| Project Title: | Soda Mountain Solar |
| Document Title: | Response to REV 2 DR BIO-2 |

Subject: Response to REV2 DR BIO-2 Soda Mountain Solar Access Road Assessment Project Site, in the San Bernardino County, California

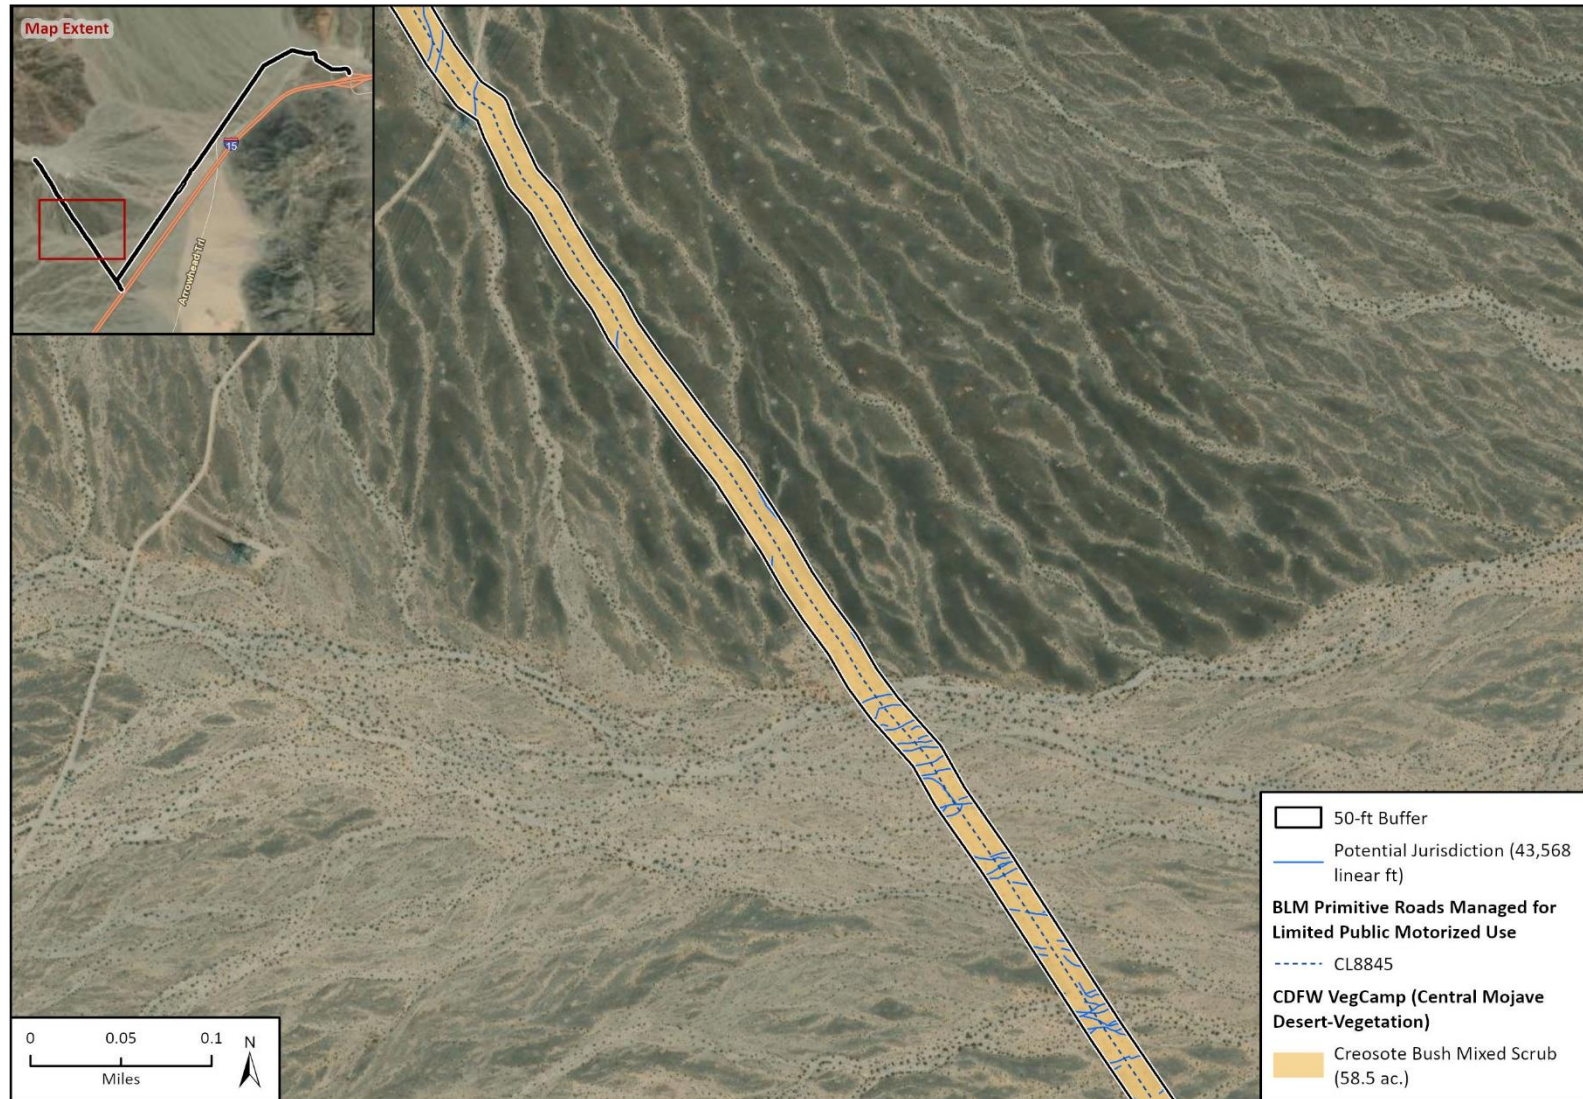
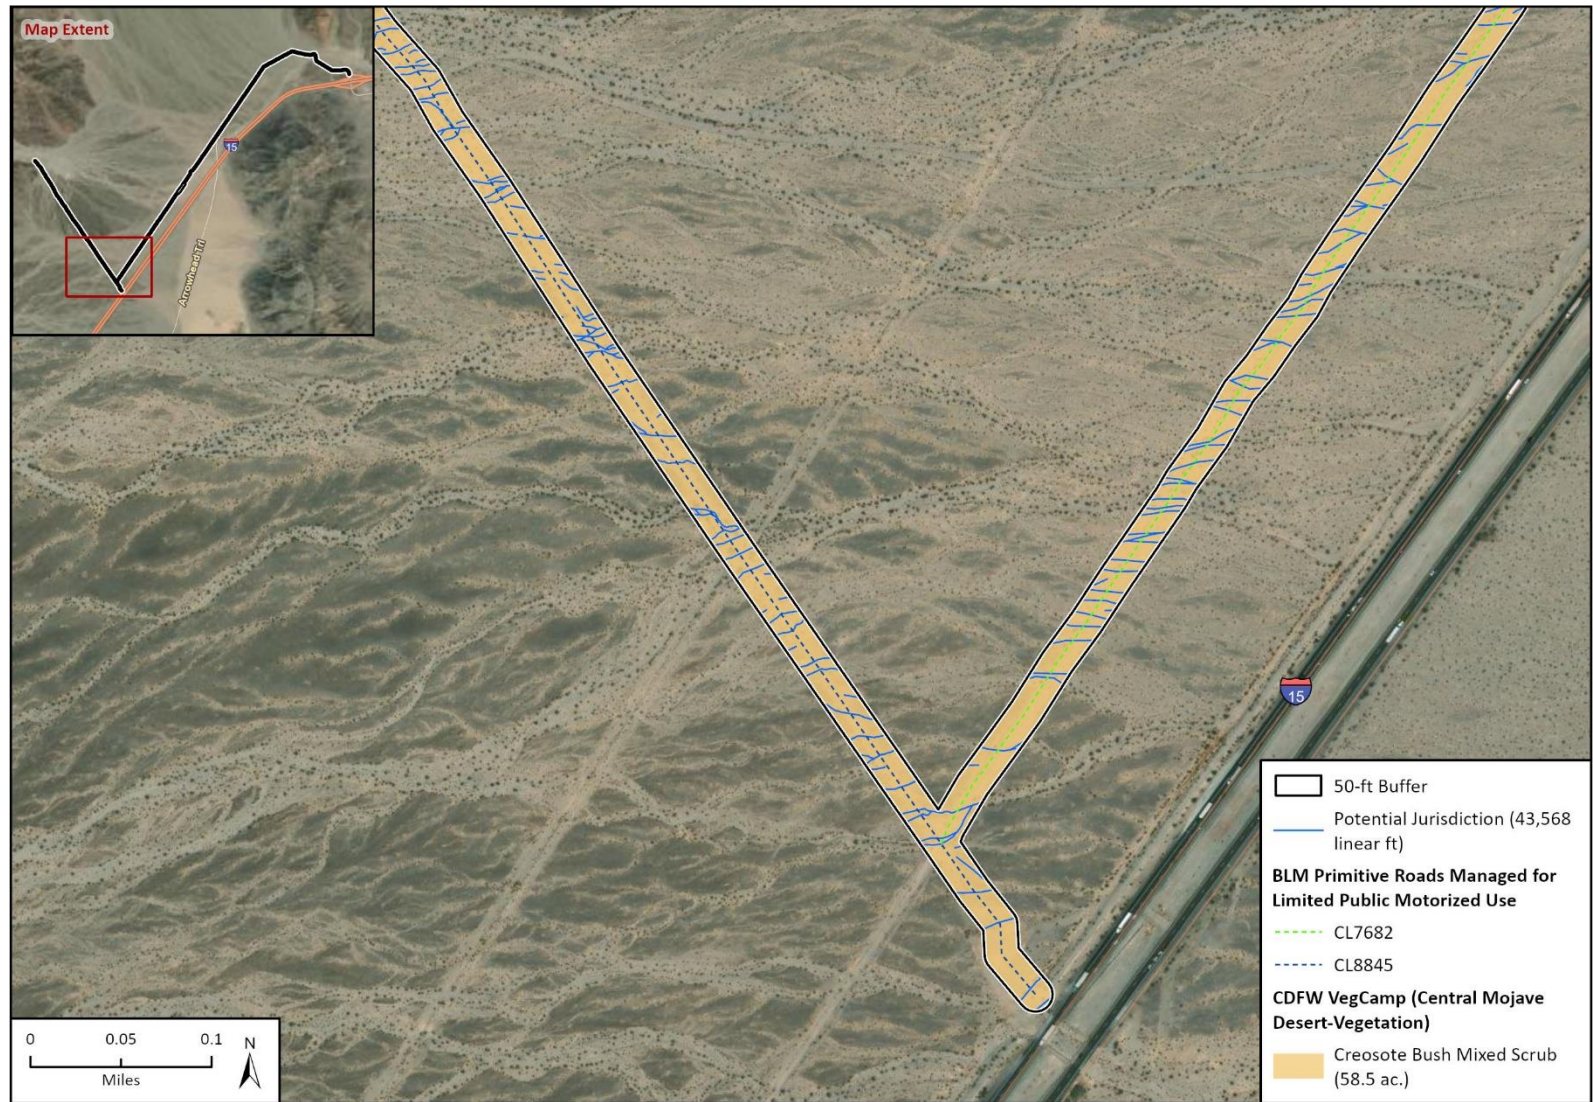
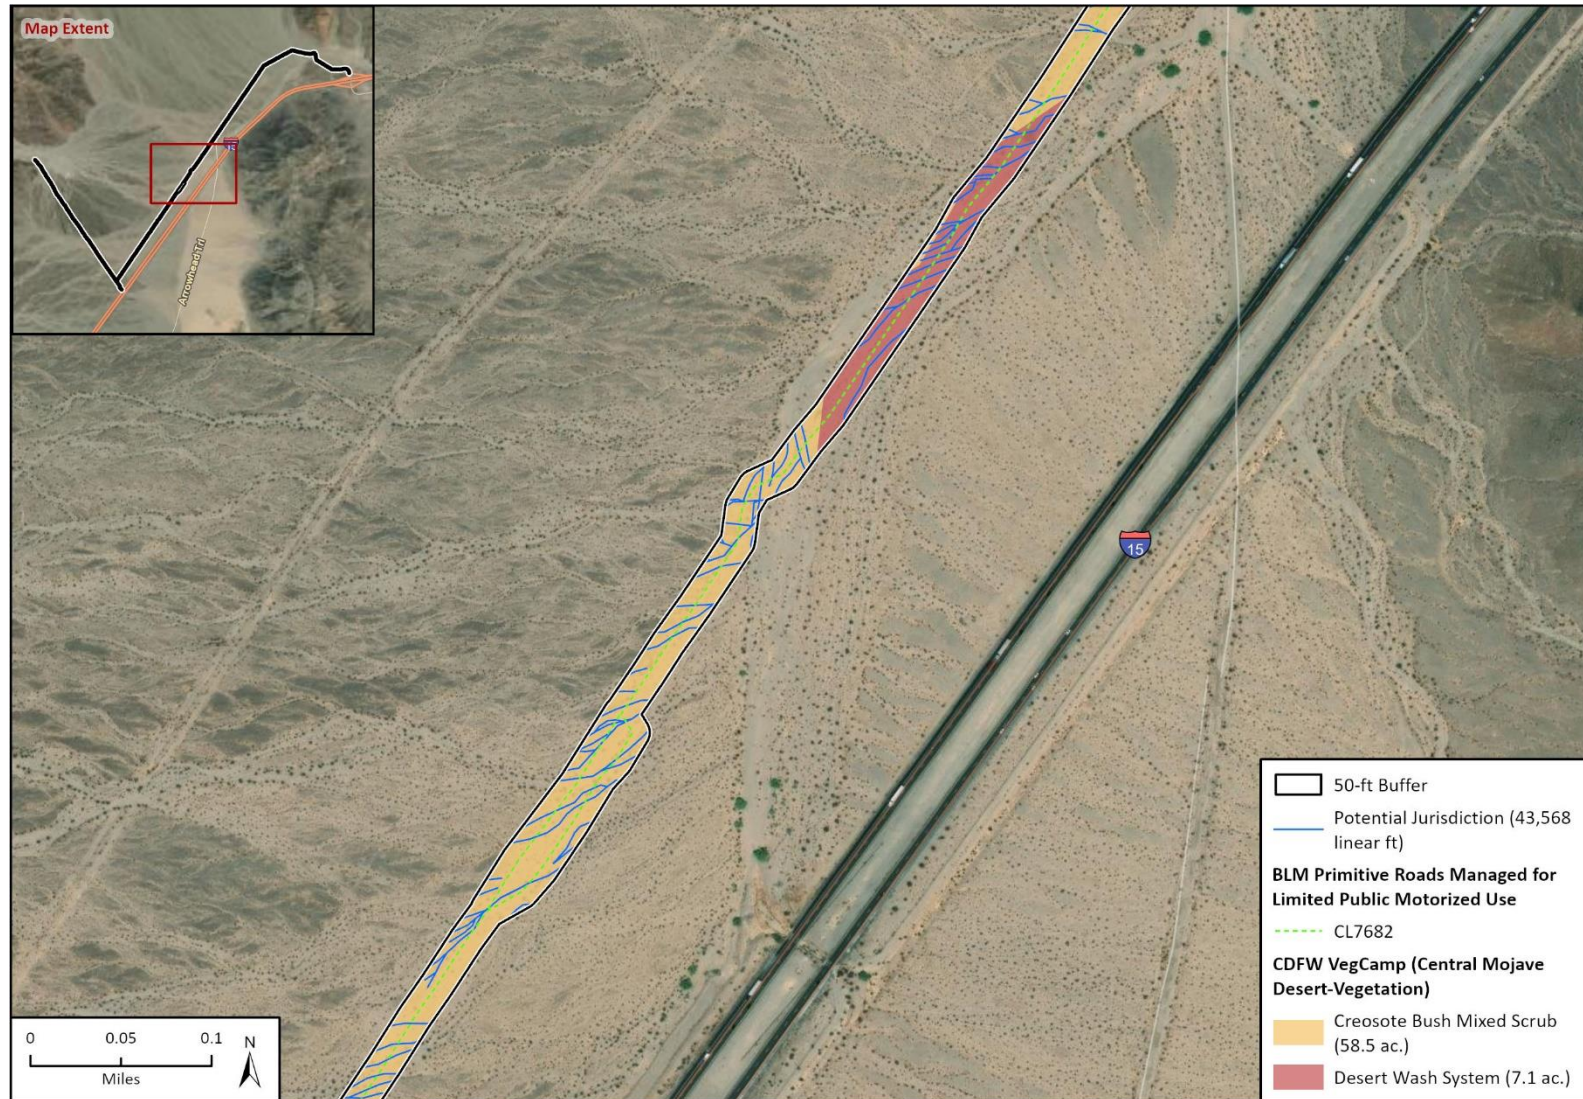
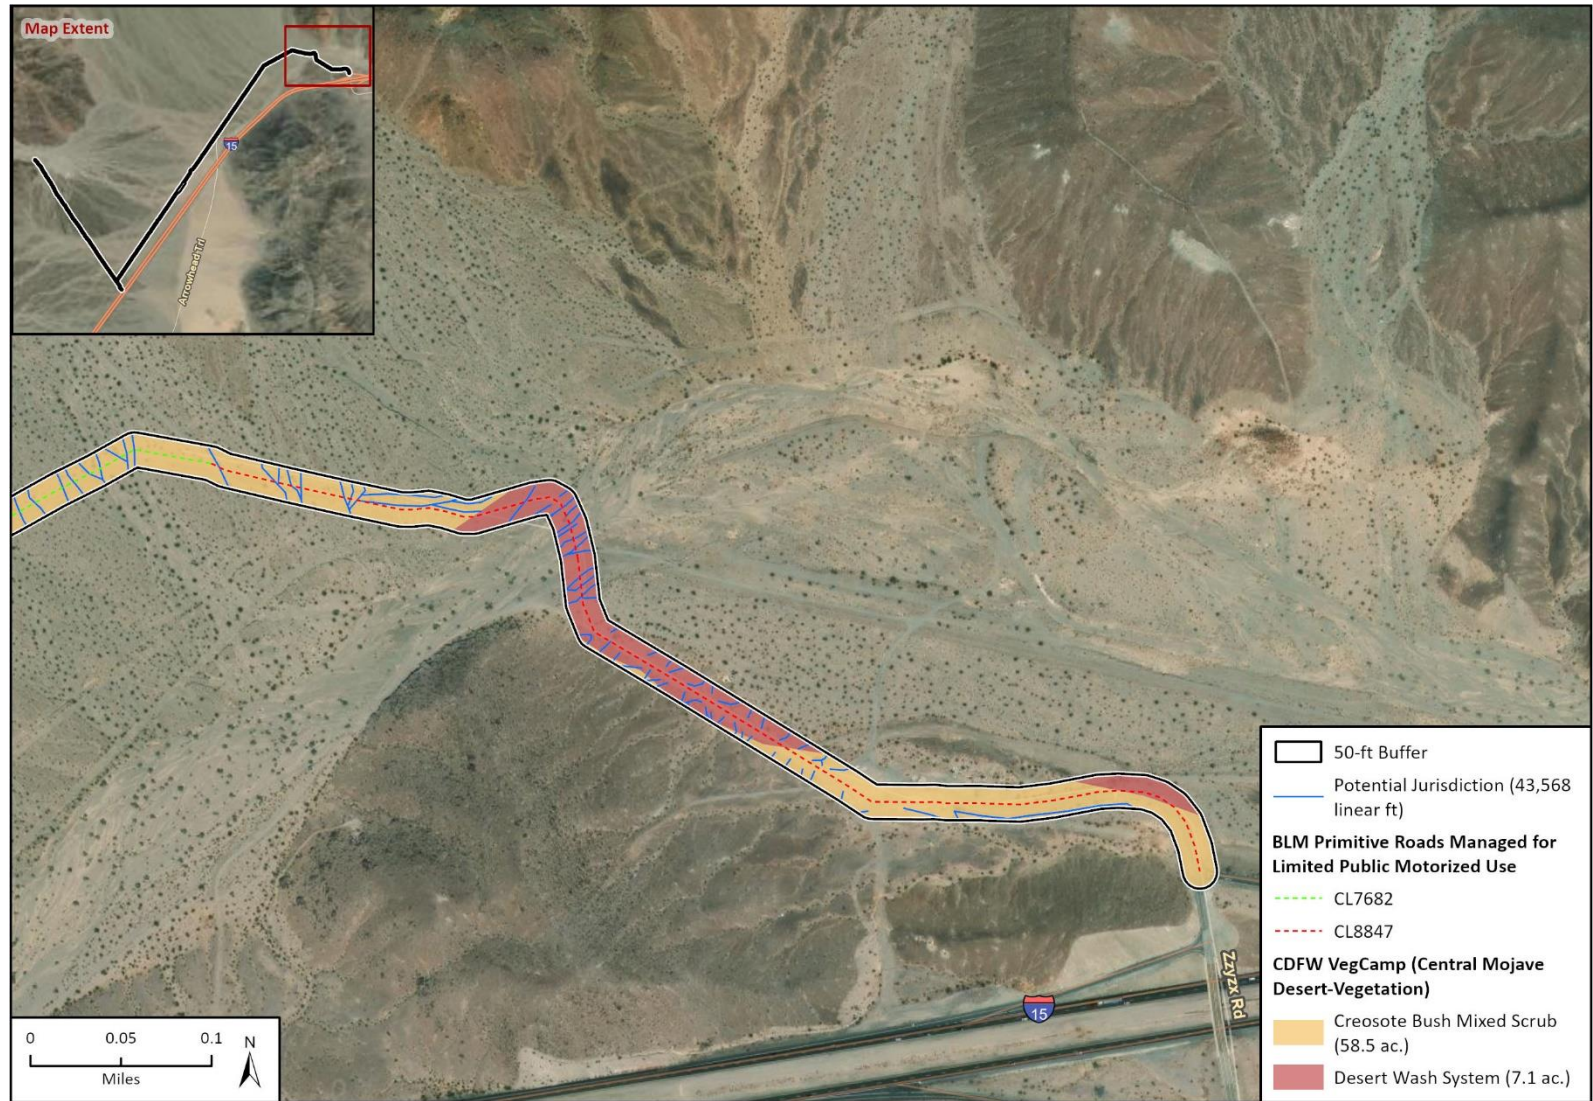
Please confirm if CL8845 is proposed for use as part of the project to access the gen-tie alignment. Additionally, please confirm that BLM roads CL8854, CL8835, CL381A, and CL8837 are not being proposed for use and that these roads are included on the figures for reference purposes only. As previously requested, please also provide biological and jurisdictional waters information that occur within a 50-ft buffer of any proposed access roads and describe any improvements that may need to occur, such as grading or repairs of drainages following large rain events.

CL8845 is proposed for use as part of the project to access the gen-tie alignment. No road improvements or maintenance will occur within the existing road.

CL8847, from Zzyzx Rd to where it connects with CL7682 is proposed for use. No road improvements or maintenance will occur.

CL8854, CL8835, CL381A, and CL8837 are not proposed for use and were included in the figures for reference purposes only.

A desktop delineation utilized NWI, NHD, ESRI imagery (ESRI 2025a), and ESRI hillshade (ESRI 2025b) data to identify potential jurisdictional features within 50 feet of proposed access roads. These features are displayed in Attachment 1, Figures 1A-1H. No new impacts to these features will occur since no improvements to existing access roads are proposed.
